MagiCAD for AutoCAD

Release notes for version 2020.1

20/08/2019

Using q50 or n50 value disables the transfer air temperature setting

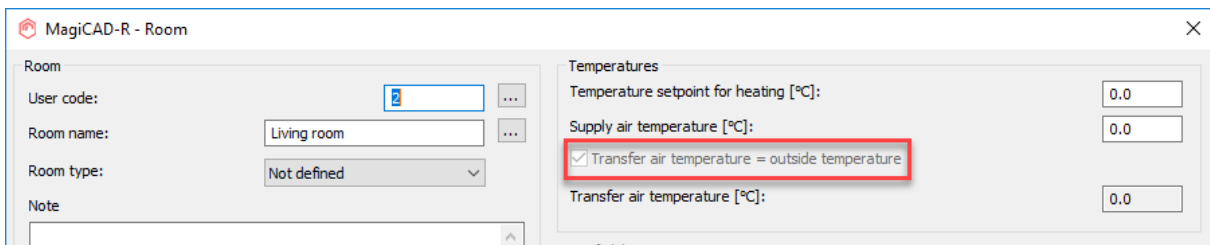
In MagiCAD for AutoCAD 2020 version using the project specific q50 or n50 value for defining the building infiltration rate, incorrectly disabled the transfer air temperature setting in each room and set the temperature to outside temperature. This caused issues when calculating the heat losses for the rooms where the supply and extract air flows were not in balance, and transfer air should have been taken from the adjacent room.

Performing Save, Calculate and Update Texts functionality resets the air exchange rates

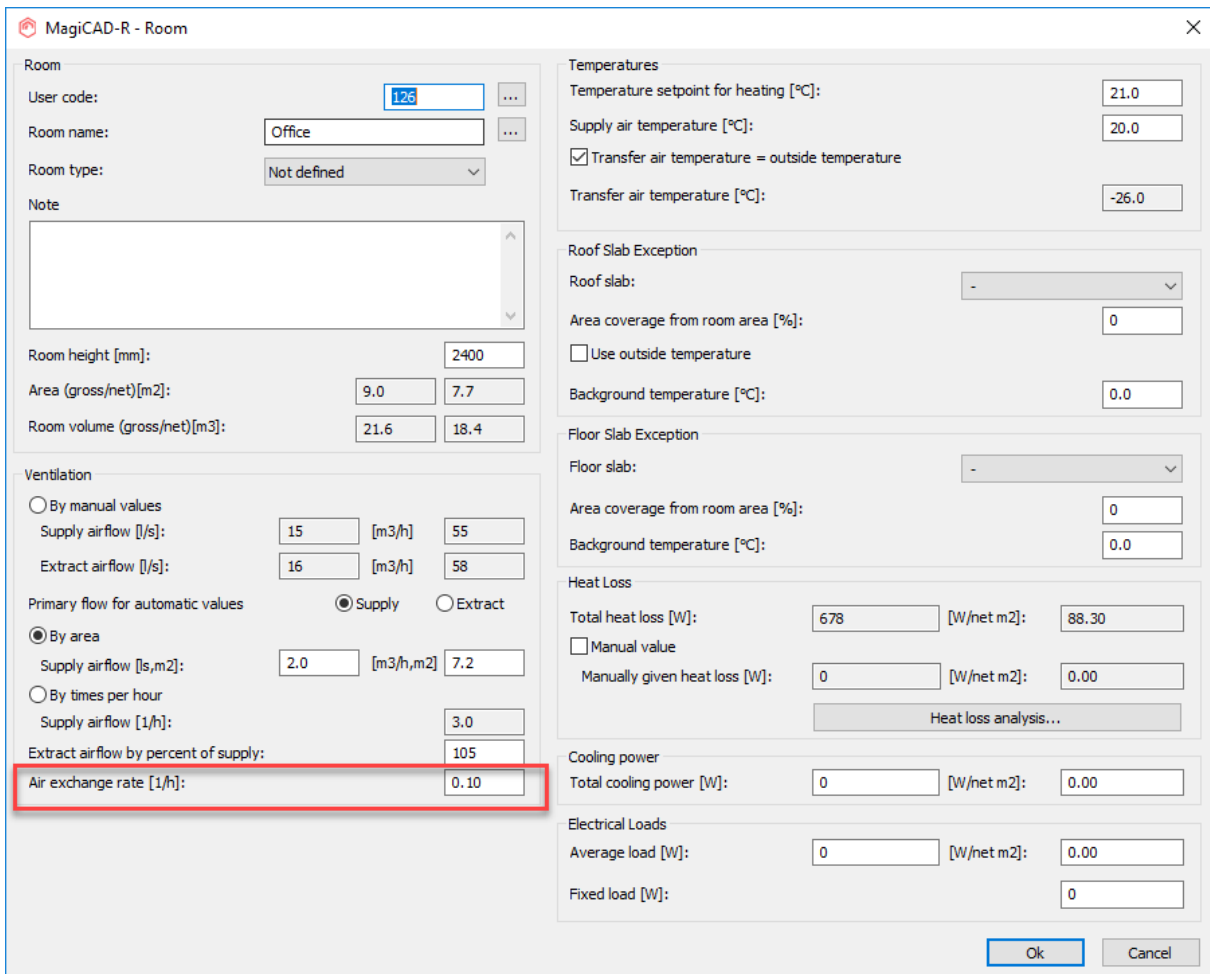
In MagiCAD 2020 version there was an issue with room air exchange rate values. If user runs Save, Calculate and Update Texts functionality to update the project, it will reset all the air exchange rate values to 0,1 1/h to all the rooms in the project. Regardless of whether user has defined different air exchange value for the rooms or not.
